**Sent:** 9/03/2020 2:26:14 PM  
**Subject:** FW: DA2020/0063 Letter of Objection  
**Attachments:** objectionDA2020063.pdf;

DA2020/0063, 18-20 Denison Street Manly NSW 2095

PLAN SHOWING DETAIL & LEVELS OVER SP 85482	
JOB No: 190337	LSA NORTHERN BEACHES
PLAN No: 190337_C	DATUM: AHD
DATE: 26/02/2019	SCALE: 1:100@A2
PROJECT: MANLY	DRAWN: FS
ADDRESS: 1820 DENISON STREET, MANLY	CHECK: GS
	SHEET 1 OF 1

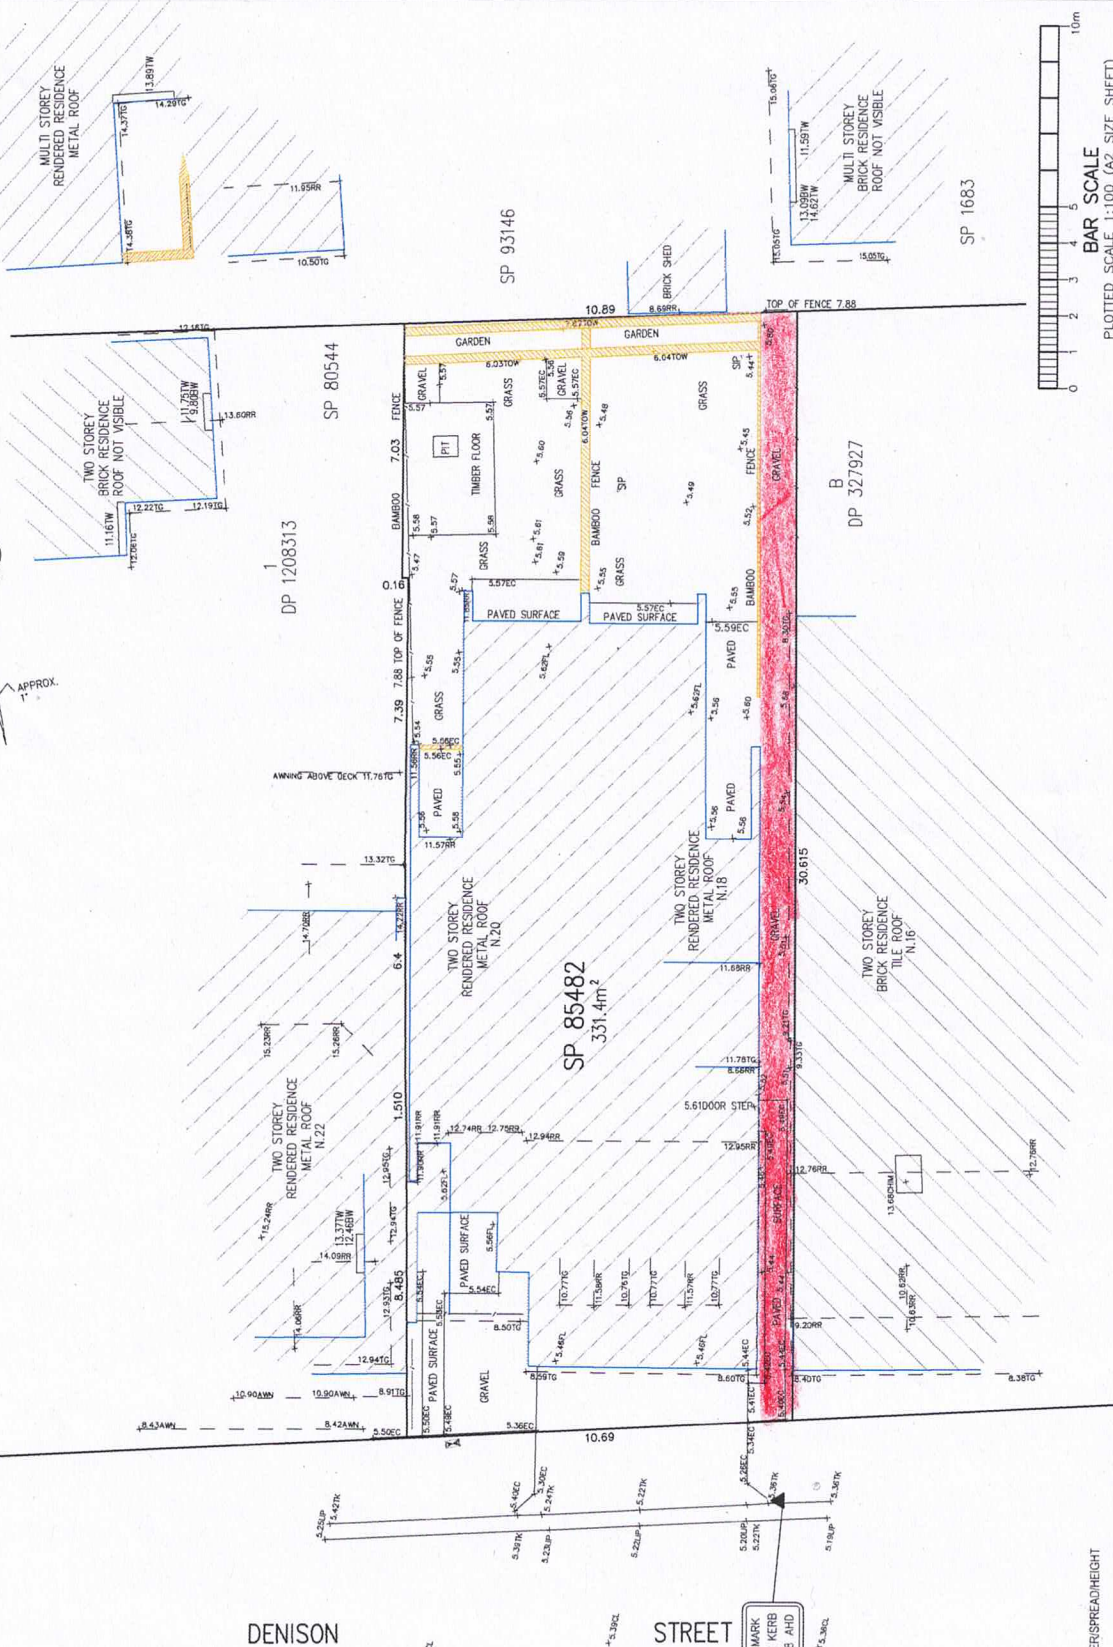
An Easement exists between 16 and 18 Denison St Manly. The easement is for the full and free passage of footway, light and air. (coloured in red, on attachments) and serves a number of properties to the east.

We request Council make a Condition of Consent, that all building structures, whether they be walls, eaves or downpipes remain clear of this Easement.

We note the owners of 18 Denison St, have recently constructed an awning, with storage in the easement. We have discussed the need for the removal of this structure with the owners and ask that Council also ensure it is removed.
